January 28, 2022

SUBJECT: PRELIMINARY PLAN – 231 & 251 St. Asaphs Road, One & Three Bala Plaza & 333 E. City Avenue, Two Bala Plaza, Bala Cynwyd. LD# 3819 & 3820. Ward. 9

**Re: One, Two & Three Bala Plaza Development
Preliminary Plan Review**

Plan Name: One & Three Bala Plaza and Two Bala Plaza

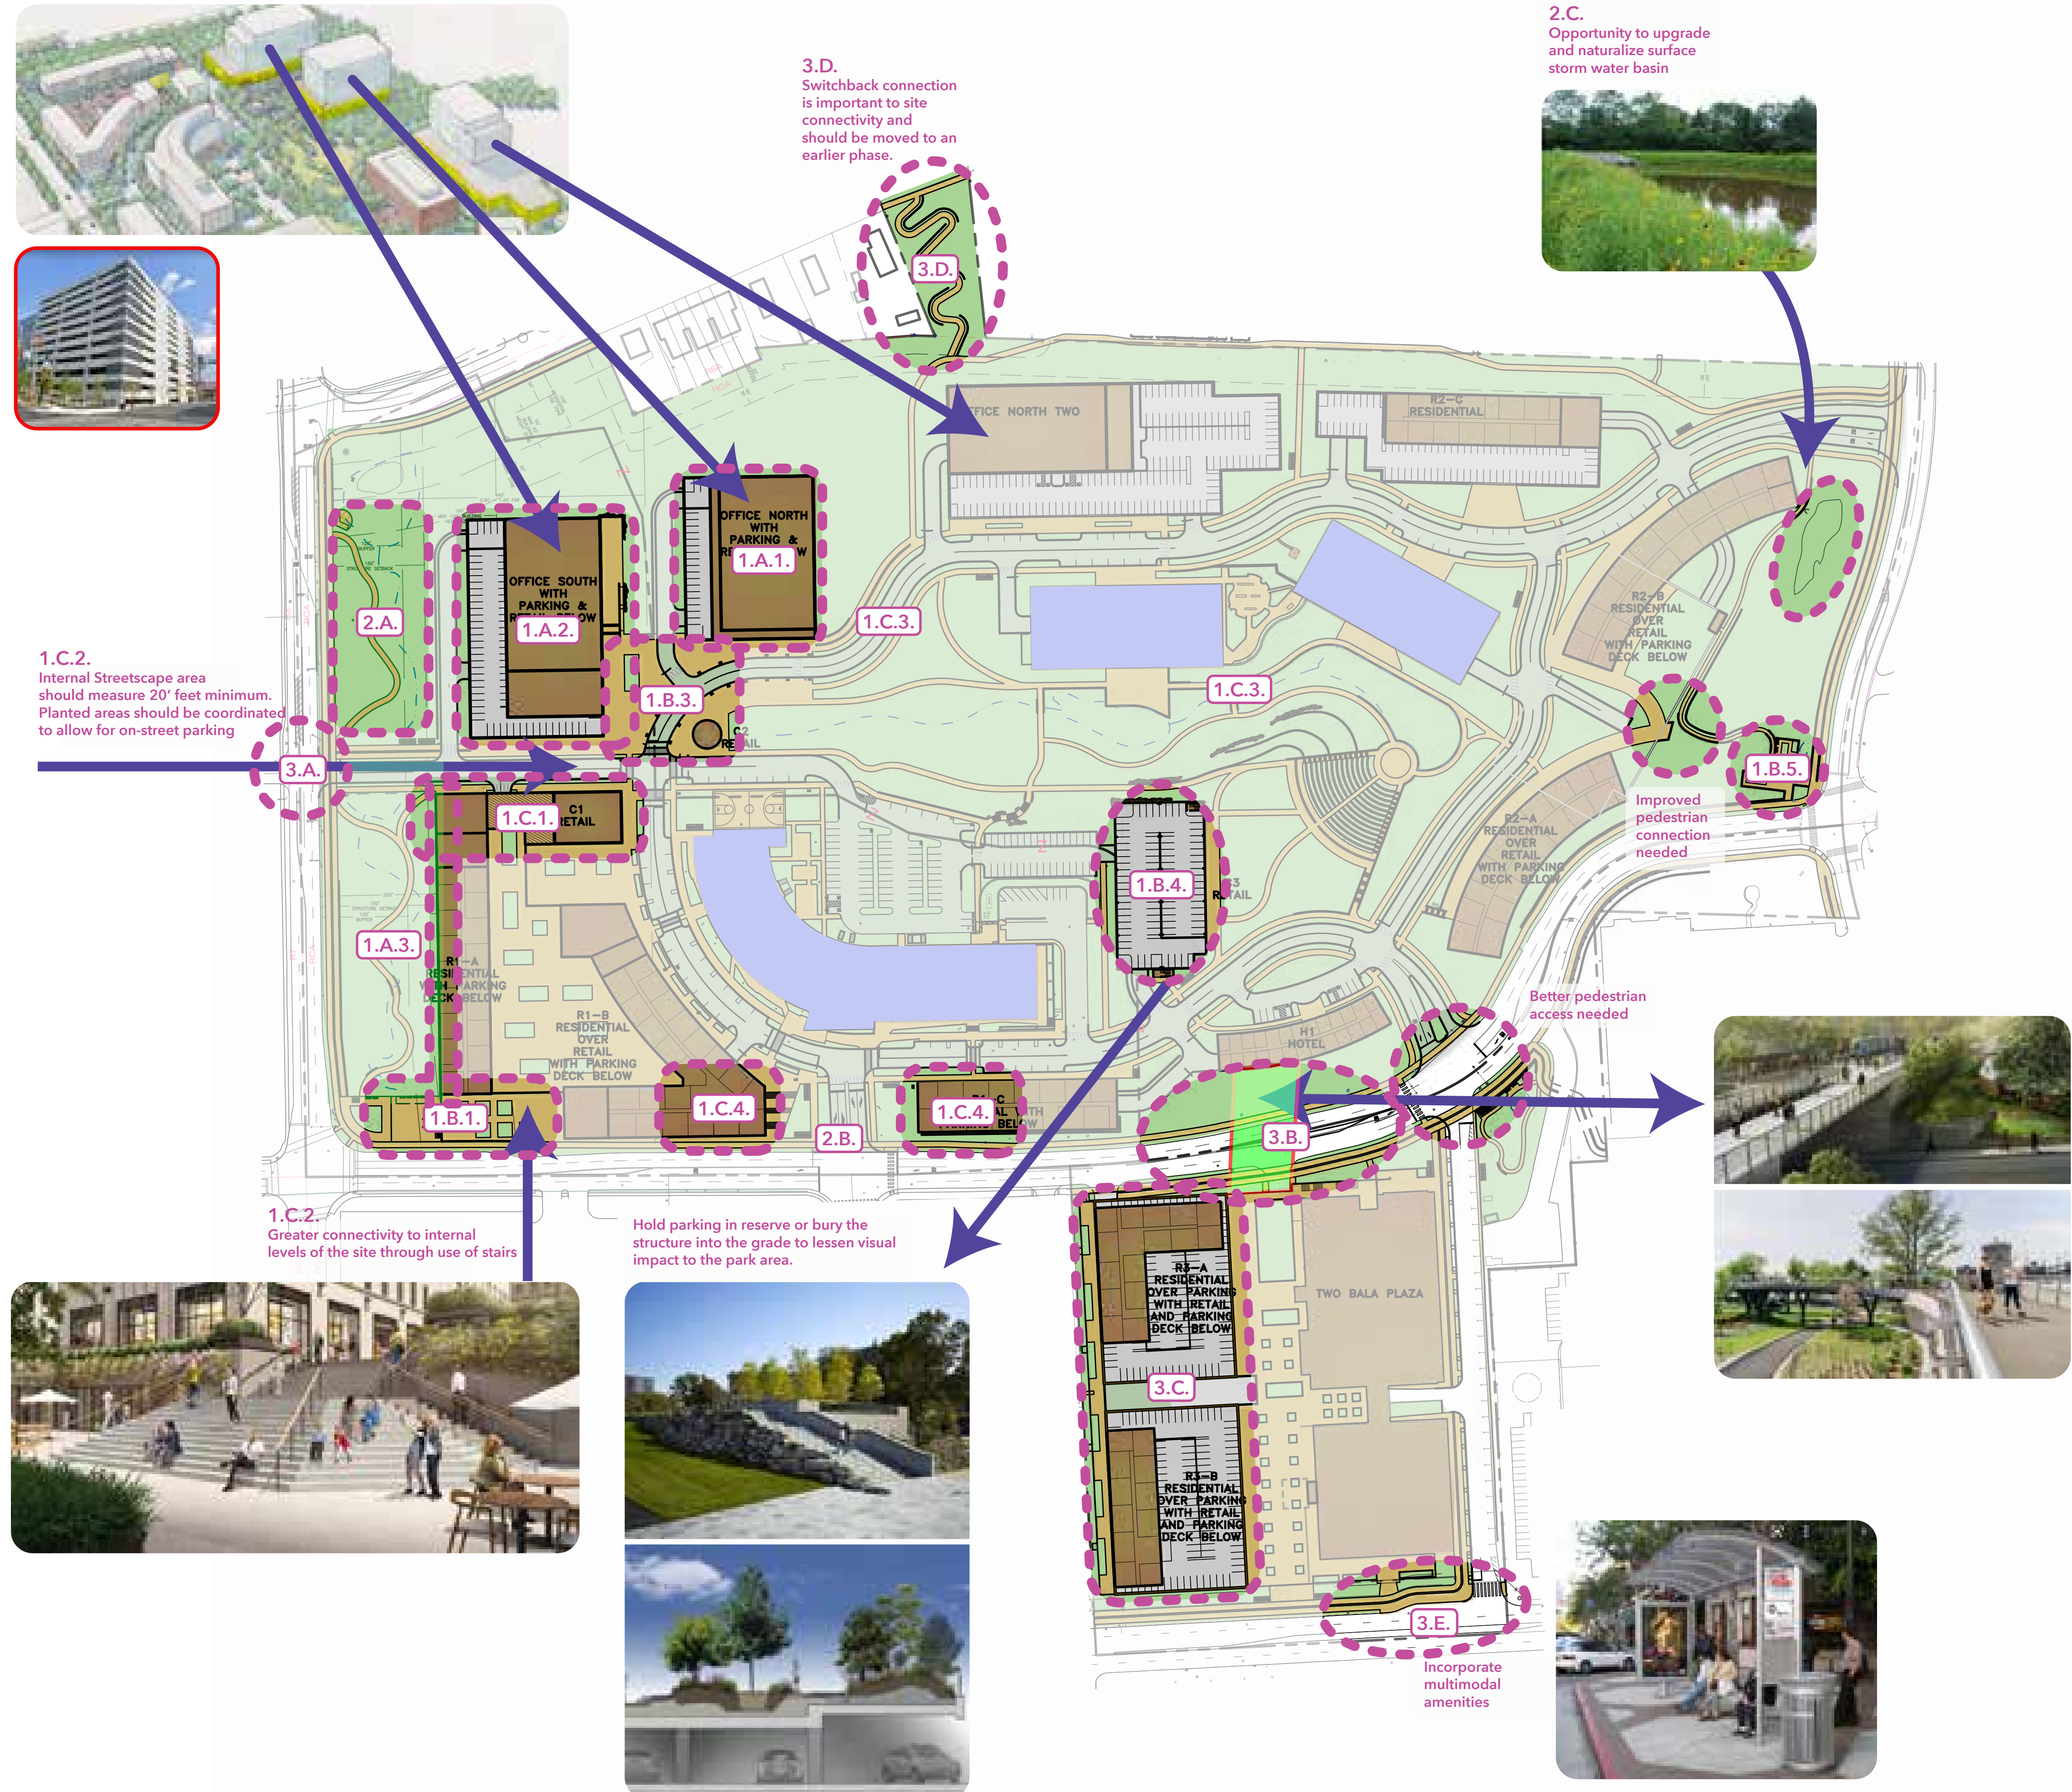
- C. Active Streetscapes:
1. The R1-A and C1 building setbacks located along the Llanberis Road extension should be increased to mirror the setback being provided on the opposite side of the street and to provide additional space for streetscape amenities, such as planted areas and outdoor dining.

2. The illustrative drawings and the plans do not seem to consistently show the streetscape space. The plan should include a minimum of 20’ to 25’ of streetscape space to accommodate necessary amenities.

3. On-street parking should be provided along all new internal roadways, to create convenient and visible metered short-term parking which will aid in the success of the commercial spaces. On-street parking has the added benefit of traffic calming and increasing pedestrian along the adjacent sidewalks.

- A. The site maintains the green area located along Belmont Avenue, which provides a valuable woodland area and buffer for the development to the adjacent residential neighborhood. Underground stormwater improvements are located within the buffer area, which would negatively impact the existing vegetation and threaten the valuable tree canopy. Underground stormwater management should be located beneath the proposed paved areas internal to the site, including the new roadways and driveways.

- B. Additional greening should be provided adjacent to the intersection of St. Asaphs Road and Belmont Avenue, extending the buffer and wrapping the corner to lessen the impact of the proposed intersection expansion.
- C. The existing surface stormwater detention basin is shown to remain and should be enhanced and naturalized.
